BCA COMPLIANCE ASSESSEMENT REPORT

14 Birkley Road, Manly NSW

**Alterations and Additions to Existing Residential Unit
Development**

Report Number	A23_122_BCA	
Revision Number	Stage	Date of Issue
01	DA- Draft	29.11.2023
02	DA	07.12.2023

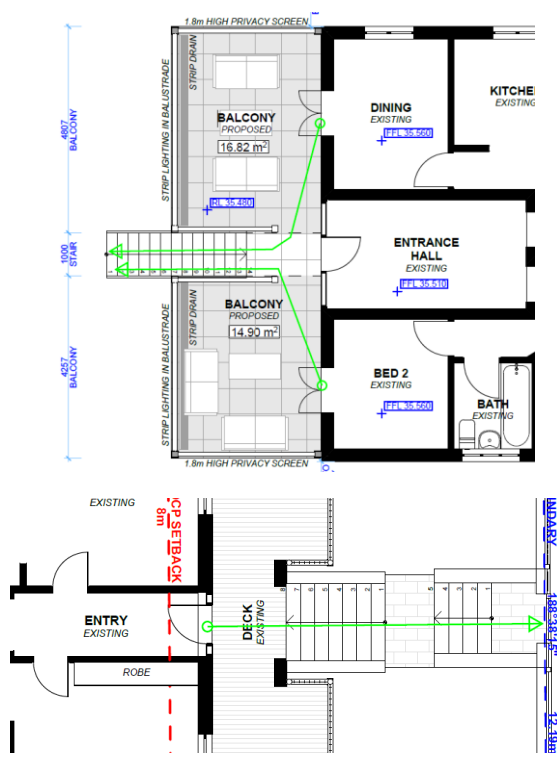
d)	<p><i>Bounding construction – egress across open balconies in Class 2 -4 parts (C4D12)</i></p> <p>Egress from the upper level units along the balcony involves passing by the external walls/doors of the common area unit on the same level (refer to plan extract below which shows available egress paths from the southern upper floor unit (shown in green) passing by the 'external' walls & door of the 'entrance hall' (shown in blue below).</p> <p>In lieu of protecting the external wall of the entrance hall, it is considered that the entrance doors to the upper levels were provided with self-closing solid core doors, that a similar outcome would be achieved.</p>

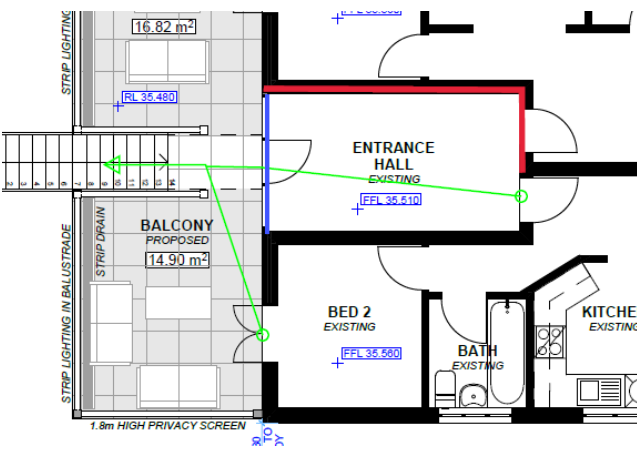
f)	<p><i>Discharge of exits (D2D15)</i></p> <p>The path of travel from the exits to the street must comply with BCA D2.</p> <p>The path of travel from the discharge of exit to the street is shown in blue below.</p> <p>The gate leading to Birkely Street should be freely operable from the inside with BCA D3D26 compliant door hardware.</p>
